Local Market Power Mitigation Enhancements Issue Paper/Straw Proposal

Comments by Department of Market Monitoring

October 4, 2018

Figure 1. Mitigation run solution

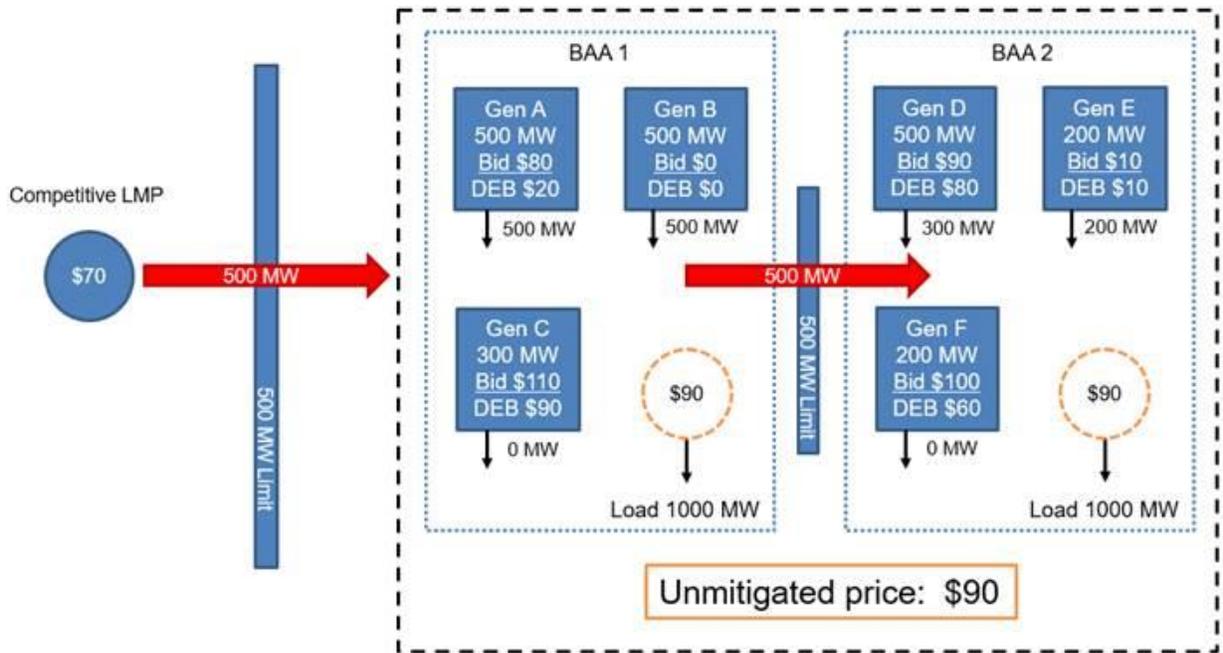
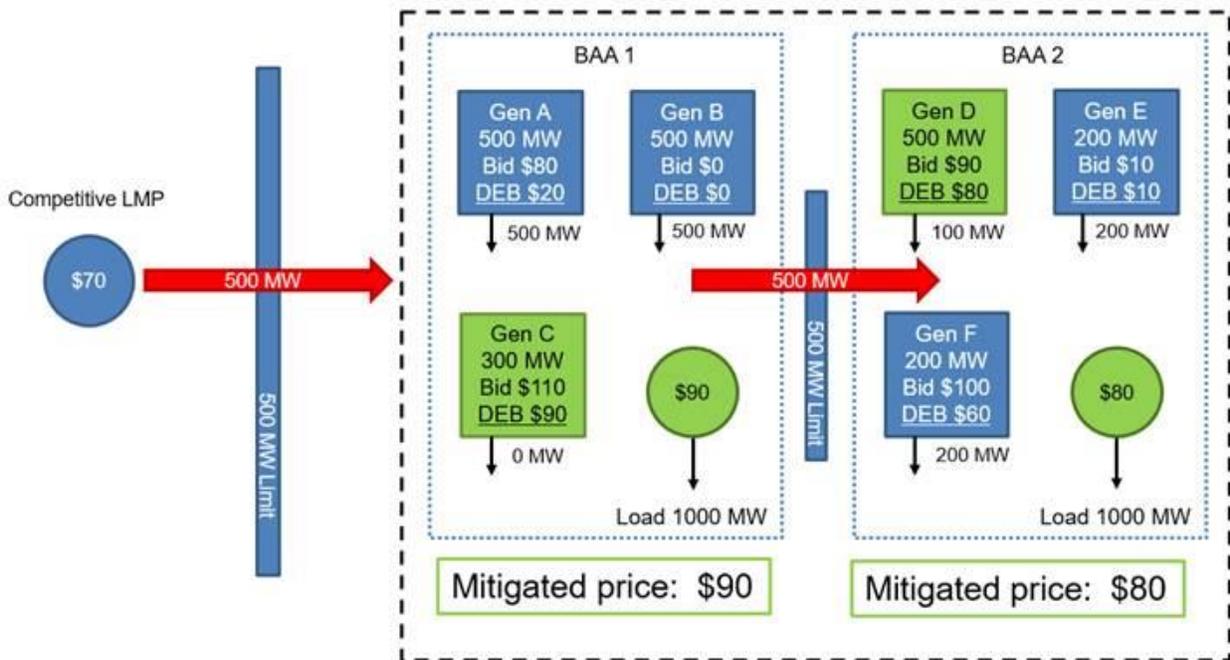
Consider the mitigation run example in Figure 1. With the unmitigated bids, a transfer of 500 MW occurs from BAA 1 to BAA 2. Figure 2 shows the prices and schedules that would occur using the mitigated bids in the market run under the ISO's proposal to limit changes in exports between the mitigation and market runs.

In this example, the ISO's proposal to not allow changes to the 500 MW transfer from BAA 1 to BAA 2 results in power flowing from the higher priced BAA 1 to the lower priced BAA 2 in the market run. This could create unintended and inefficient outcomes and behavioral incentives.

The ISO should thoroughly vet with stakeholders the potential implications of a market design that allows power to flow from a higher priced area to a lower priced area. Initial areas of concern include:

- 1) RTCIO calculation and allocation; and
- 2) Incentives for market participants to submit bids that do not reflect true marginal costs but that create flows from higher priced areas to lower priced areas that the participants could profit from

If the ISO decides to continue to consider this policy in its next proposal, DMM recommends that the ISO provide more specific details on the proposed design. The relationship between transfers that are fixed from the mitigation run of a 15-minute interval and the transfer capability that the ISO proposes to use in the corresponding 5-minute interval is unclear. Would the transfers be frozen in the 5-minute market as a result of the 15-minute mitigation run results? The ISO should define the precise circumstances under which transfers in the 15-minute market and 5-minute market would be frozen.
